ETE Road Map

Qualification of Valves

Final Monitoring Report

Report to the Federal Ministry of Agriculture,
Forestry, Environment and Water Management
of Austria

Figure 3: BRU-A Valve type Chekhov Type 1115-300/350 (WWER-1000)

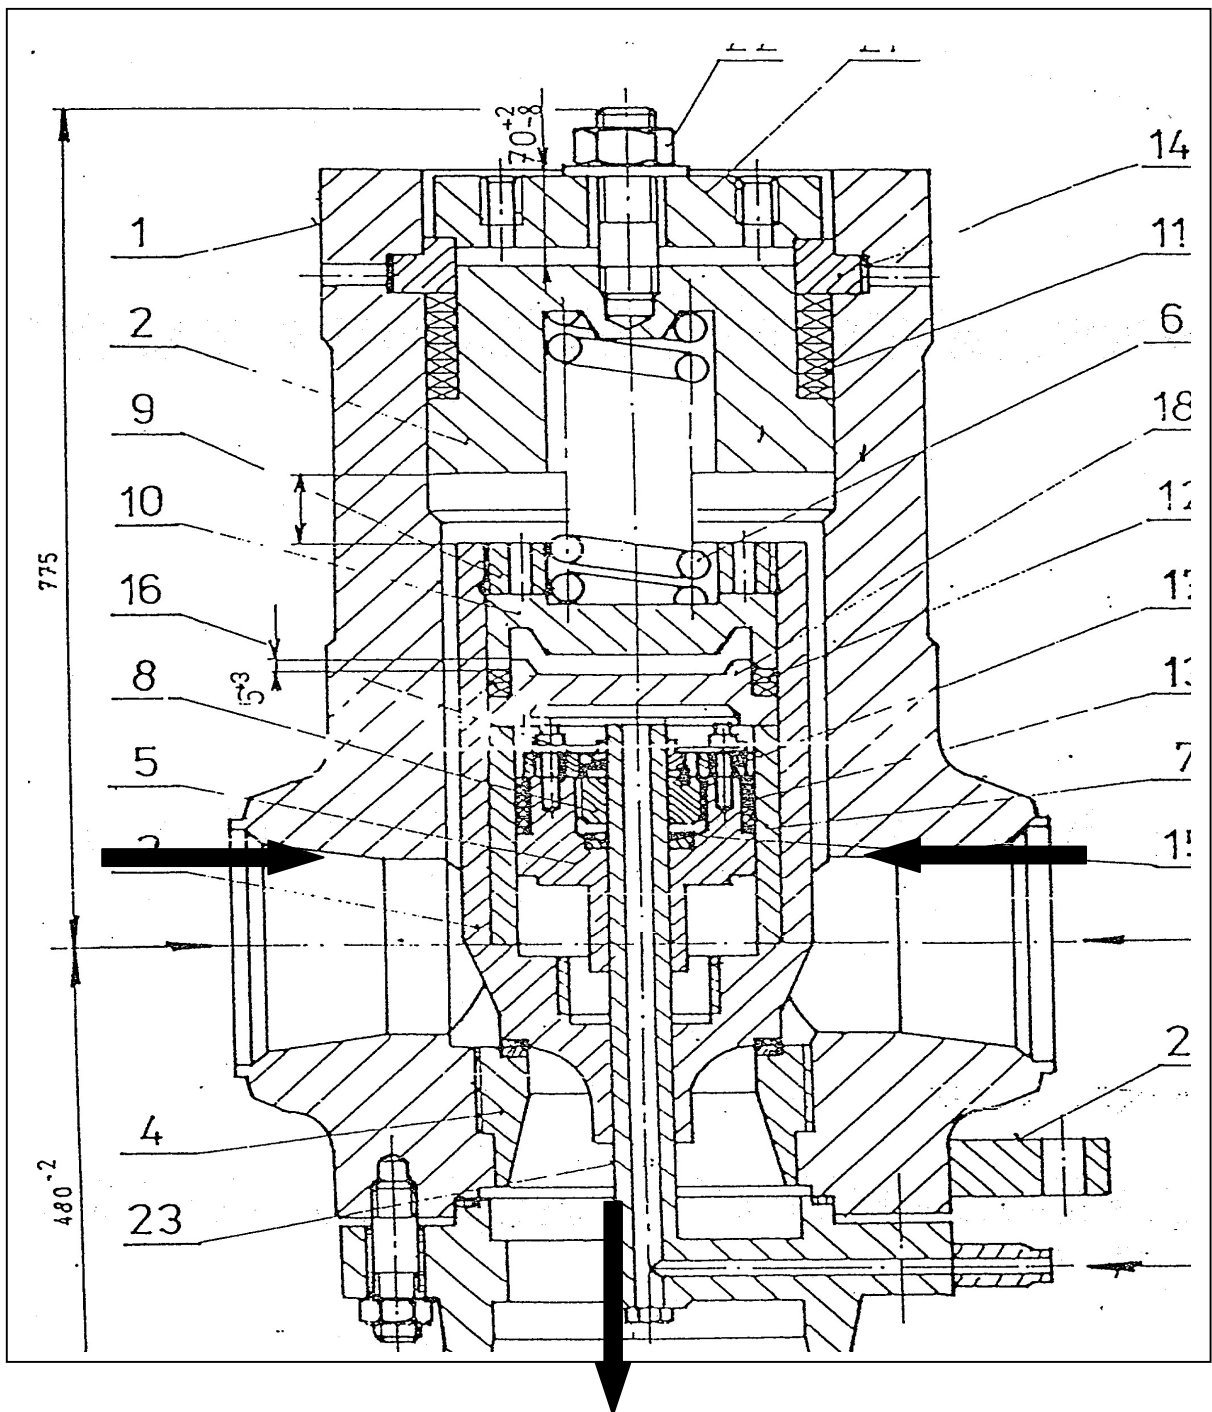
Three piping loops are connected to each steam pipe with T-joints. These are referred to as "bubliks". The bubliks lead to the main steam relief valve (BRU-A, see Figure 3) and two bubliks lead each to one main steam safety valve (MSSVs, see Figure 4). Functional qualifications of these valves are in question here.

- The ASME code requires, beside other defined test conditions, that tests have to be planned. The parent BRU-A was actuated at one occasion, which seems to have been a spurious event rather, than a test under planned conditions for two-phase flow, because two-phase flow conditions developed quite unexpectedly, as reported by the TSO at the Workshop. Inasmuch as there is only a single and unplanned two-phase flow test of the parent BRU-A valve, the Temelín candidate BRU-A valve cannot be considered to be qualified for two-phase flow.

The tests should be performed for the actual Temelín valves (together with the new actuator in the case of the BRU-A and the new pilot valve in the case of the MSSV), because otherwise two parent valves for each type of valves will have to be tested for compliance with ASME code requirements. The test conditions should, to the extent possible, represent actual plant conditions under which the "candidate" valves should be operable. (Test for water flow at a temperature of about 300°C, as encountered with large primary to secondary leaks, instead of 100 °C as was done in the test of the MSSV "parent" valve – see APPENDIX II).
